### **CLOSURE OF NEW APPLICATION WORKSHEET**

FROM: Doug Schemm RE: Application, File No. 50,195

## Technical Review of Application 50,195 filed by Judith Reedy

## FINDINGS AND ORDER IN THE MATTER OF THE DISMISSAL OF APPLICATION FILE NO. 50,195

Figure 1. Two-mile circle around File 50,195 with six existing irrigation wells to the west and two domestic wells to the east and south. Confined Dakota aquifer mapping shown in light green and mapped as unconfined in dark green. Alluvial deposits shown in yellow.

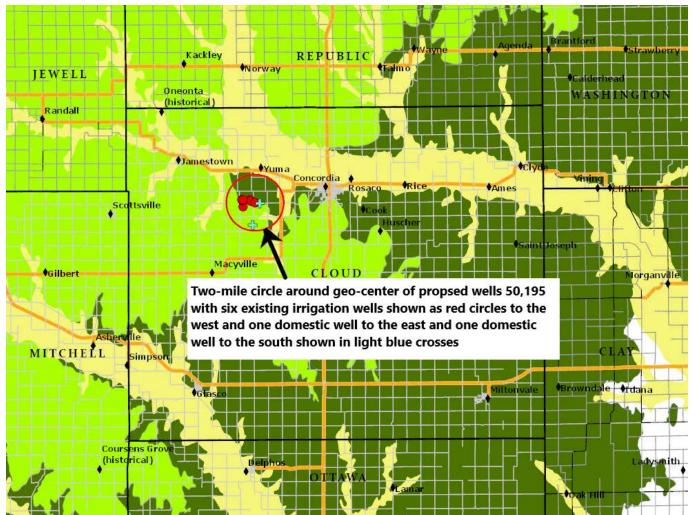
One-half mile well spacing is not met with wells File No. 49,331. Well spacing to the nearest domestic well is met but there is still a concern to possible impairment due to the number of existing large capacity wells. **Figure 1.**

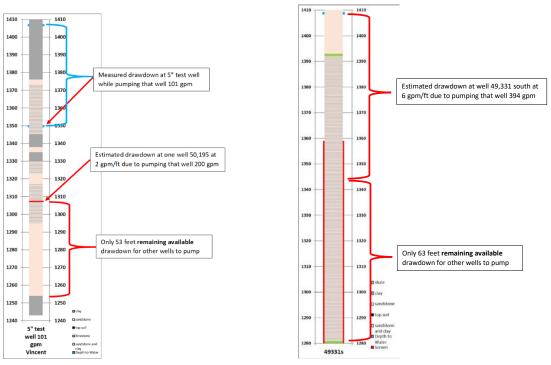
GWA suggests a low specific capacity of about 2 gallons per minute per foot drawdown (gpm/ft) during test pumping the 5" well at 101 gpm may be due to poor well construction. But a specific capacity is also about 2 gpd/ft at irrigation well 49,333 west well according to the well driller's log. At a specific capacity of 2 gpm/ft and four 200 gpm wells for 50,195, remaining available drawdown at the new wells with a potentiometric head of 153 feet may be about 53 feet. A greater specific capacity of about 6 gpm/ft can be estimated from information in the driller's log for well 49,331 north well. The DWR field inspection report shows the two wells pumping together yields 785 gpm. At 392 gpm per well with a specific

capacity of 6 gpm/ft, remaining available drawdown at 49,331 with a potentiometric head of 128 feet may be about 63 feet drawdown at each well. **Table 1.**

Figure 8. Simulating pumping only 3 of the 4 wells at 200 gpm each does not allow enough available drawdown for the  $4^{\rm th}$  well for 50,195 to pump.

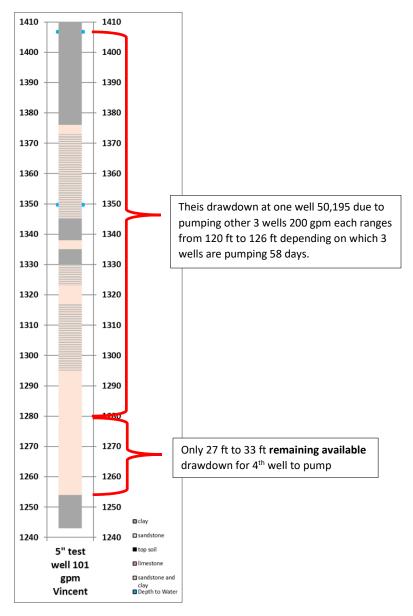
Ignoring the specific capacity assumptions, the aquifer test conclusions provide aquifer parameters to simulate drawdowns at one or more wells due to another well or wells pumping. Application, 50,195 proposes 4 wells located 150 feet apart pumping 200 gallons per minute each for 58 days for a total of 800 gallons per minute and 208 acre-feet. Simulating only 3 wells pumping 200 gpm each for only 600 gpm for 58 days shows a drawdown of 120 to 126 feet from a potentiometric head of 153 feet and does not leave enough available drawdown for the fourth well to pump. **Figure 8.**

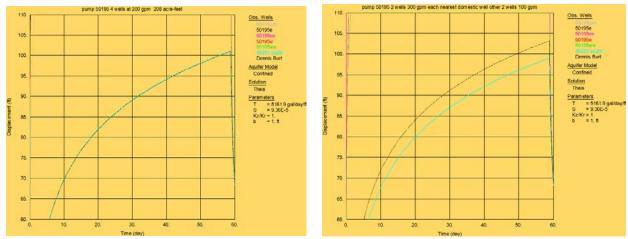
If the requested rate and quantity could be pumped from 50,195, drawdown caused by the proposed 4 wells is sensitive to the gallons per minute per well and the location of the 4 wells. Simulating 300 gpm from each of the two wells 50,195 located closest to the domestic well and 100 gpm each from the two wells 50,196 closest to the nearest irrigation well results in greater drawdown at the domestic well than at the nearest irrigation well by a few feet. **Figure 9.**

Figure 10. Simulated drawdown at the proposed location 50,195 exceeds the potentiometric head of 153 feet measured in February 2020 if all 6 existing irrigation wells pumped their tested rates and authorized quantities.

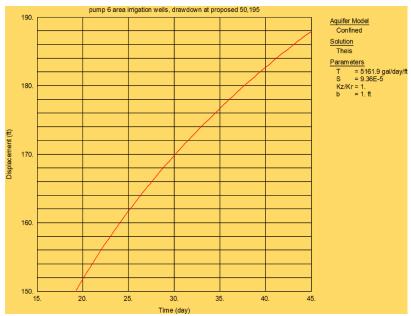
Simulating pumping all 6 of the presently existing irrigation wells their tested rates and authorized quantities shows there is not enough water to pump at the proposed location 50,195. After 20 days pumping all 6 irrigation wells, drawdown at the proposed 50,195 exceeds a potentiometric head of 153 feet measured in February 2020. **Figure 10.**

Figure 11. Drawdown at the nearest domestic well if all six existing irrigation wells could pump their authorized quantities at their tested rates and 50,195 pumped as proposed.

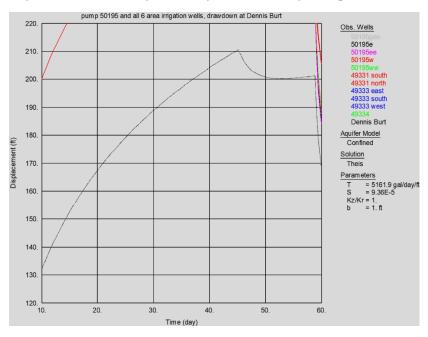
Pumping all 6 of the presently existing irrigation wells and 50,195 wells shows drawdown at the nearest domestic well would exceed the potentiometric head of 153 feet after about 15 days and exceed it by 137% by about 45 days. **Figure 11.**
